Appendix 1:

Information requested under Clause 23(2) of First Schedule of the Resource Management Act 1991

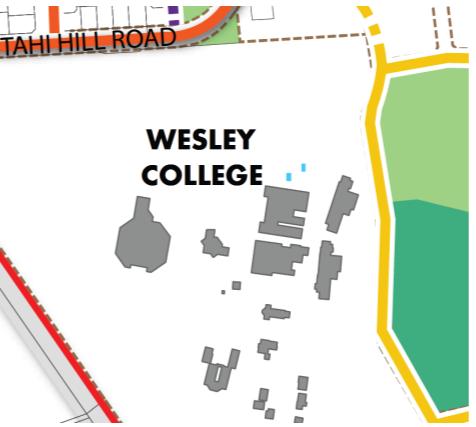
Urban design and landscape – Rebecca Skidmore, R.A. Skidmore Urban Design Ltd					
UD1	Urban design – effect of NZTA Link Road designation	<p>Please advise whether the indicative drawings contained in the Urban Design Plan set have taken account of the NZTA designation for the Link Road from SH22 and confirm the implications the designed street link will have on the urban structure and development pattern depicted in the drawings.</p> <p>Reasons:</p> <p>To better understand the implications of the designation and delivery of this roading connection on the surrounding urban structure and form.</p>	<p>The urban design plan set has been developed taking into account the designation and design of the Link Road. The urban design approach in the precinct plans and the plan set ties in with the proposed block structure that integrates with the design of the Link Road. This ensures there is an efficient urban layout that maximises development and orientates blocks and local roads to achieve connected and accessible neighbourhoods and minimises rear lots. It can also achieve an appropriate interface to the boulevard type road that will carry traffic from SH 22 and could lead to the future Proposed Drury – Pukekohe Link Road.</p> <p>It is understood that following the completion of the construction of the Link Road, a review will be undertaken to determine any areas that are no longer required for the long-term development, operation, or maintenance of the Link Road. This is evident in Figure 1 below, which shows the road design for construction with the wider designation boundary extent (shown with a yellow line), the Link Road occupies a significantly smaller area. Once completed, the block/lot boundaries can be adjusted during the detailed</p>	<p>No further information request.</p>

#	Information category	Further information requested	Applicant Response	Second Request for information	GDL Response
			<p>design stage, though the overall block structure is already established.</p>  <p>Figure 1: Construction drawing for the Link Road being constructed as part of Designation No. 6311 Paerātā Station Interchange and Accessway</p>		
UD2	Urban design - topography	<p>Please provide additional analysis of the topographical constraints within the Precinct on urban form outcomes (particularly in relation to the THAB zone).</p> <p>Reasons: The UDA report identifies areas of steeper contours as a constraint requiring thoughtful design solutions. The request is made to better understand the extent and magnitude of the constraint and the likely implication on urban form outcomes.</p>	<p>The additional topographical constraints information within the Precinct is provided in Attachment 1, Drawing SK003.</p>	<p>Please provide a key for the elevation categories depicted in Sheet SK003 of the updated Urban Design Plan Set.</p>	<p>The key to the elevation categories is included in the top left-hand corner of the drawing.</p>

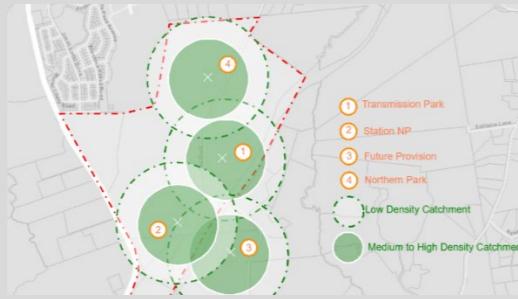
UD8	Urban design – design outcomes	<p>Please identify how a number of the design outcomes outlined in the UDA report (such as design integration with the transmission lines) will be achieved through either the underlying zone provisions or the Precinct Provisions.</p> <p>Reasons:</p> <p>The UDA report includes reference to a number of detailed design outcomes (including provision of an indicative masterplan, open space design elements and methods to achieve integration with the transmission line corridor. The request is made to understand how key outcomes will be achieved at the resource consent stage, either through the underlying zone provisions or the Precinct Provisions.</p>	<p>The principal design outcomes for the Precinct will continue to be achieved through the subsequent stages and phases of subdivision and development within the Precinct. Each phase and stage of subdivision will be the subject of a subdivision consent application. Prior to lodging any application, there will be discussions with the requisite parts of the Council and Council Controlled Organisations (i.e., Auckland Transport, Parks, Healthy Waters) and, where applicable, central government agencies, including NZTA, KiwiRail and Transpower. The applications will be guided by the provisions of the AUP, including the relevant zoning provisions, the Precinct provisions, the Overlay and the Auckland-wide provisions.</p> <p>The Precinct provisions in particular address the specific requirements related to transport, stormwater management and subdivision, including the continued restoration of the riparian margins within the Precinct. Applications will be guided not only by the zone and Auckland-wide objectives, policies and standards but also by the Precinct specific provisions, which set out the nature and timing of transport upgrades, the indicative road layout, cycle and pedestrian network and stormwater management requirements.</p> <p>In relation to the Transmission Corridor, an agreement has been reached between GDL and Transpower to realign the Transmission Corridor within the Precinct from GLN-DEV-A0016 (the most westerly pylon within the precinct) to GLN-DEV-A0019 (the most easterly in the precinct). This realignment of the corridor sees the transmission lines moved to the east, parallel to the rail line and then follow</p>	<p>No further information request</p>

#	Information category	Further information requested	Applicant Response	Second Request for information	GDL Response
			<p>the alignment of the proposed new collector road, which will run along the southern boundary of the College and connect to Paerātā Road (SH 22). The lines will be moved to monopole structures.</p> <p>The Master Plan and Urban Design Statement have been updated to reflect the realignment of the Transmission Corridor and to demonstrate how the requirements of the National Grid Corridor Overlay (Chapter D26. of the AUP) can be accommodated. The realigned Transmission Corridor will follow the riparian margins or the road reserve with the space utilised by berms, footpaths, and cycleways. Only a small portion of the corridor overlay will cross private lots, and, in these areas, there will be a no-build buffer zone. Further detail is provided in section 3.3 of the Urban Design Assessment (Refer to Attachment 2). Ultimately, the final design must comply with the standards of the National Grid Corridor Overlay, which will be assessed during the resource consent stage. To ensure future subdivision appropriately integrates blocks and allotments with the transmission lines and National Grid Corridor Overlay, the assessment matters have been updated in the precinct to include reference to the design solutions included in the Urban Design Statement as options to manage the potential effects.</p>
